## XC2300S Derivatives

16/32-Bit Single-Chip Microcontroller  
with 32-Bit Performance

Errata Sheet

V1.2 2013-09

**Figure 1 Critical application reset sequence**

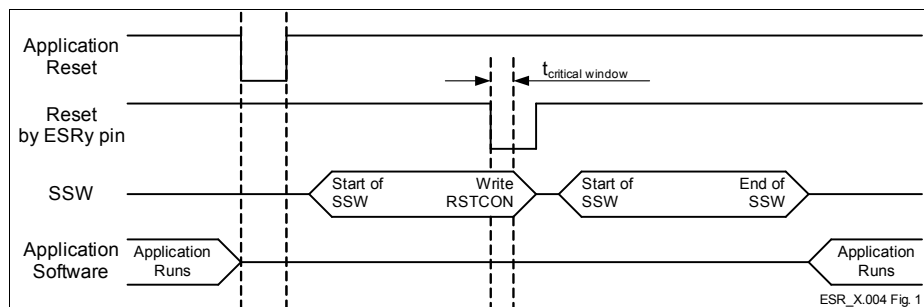
## **ESR\_X.004 Wrong Value of SCU\_RSTCONx Registers after ESRy Application Reset**

SCU\_RSTCONx registers are reset only by Power-On, but they may be wrongly affected after a second application reset requested by an ESRy pin. This may lead to the SCU\_RSTCONx register values being set to zero, which could unexpectedly disable reset sources within the user application. The conditions which lead to this behavior are:

1. First, an application reset by SW (software), CPU (Central Processing Unit), MP (Memory), WDT (Watchdog Timer) or ESRy (External Service Request y) occurs.
2. Following this, an application reset on an ESRy pin occurs.
3. If the above mentioned ESRy reset occurs during a critical time window of the SSW (startup software), then it's possible that the application will operate with the wrong SCU\_RSTCONx register value. The critical time window occurs when the SSW is writing the SCU\_RSTCONx registers, and at the same time, the ESRy reset request is processed by the reset circuitry. The width of this critical window  $t_{\text{critical window}}$  is less than 13 cycles.

- Initialize SCU\_RSTCONx registers by user software after any reset, or
- assure that a second application reset request with an ESR pin does not occur during the critical time window.
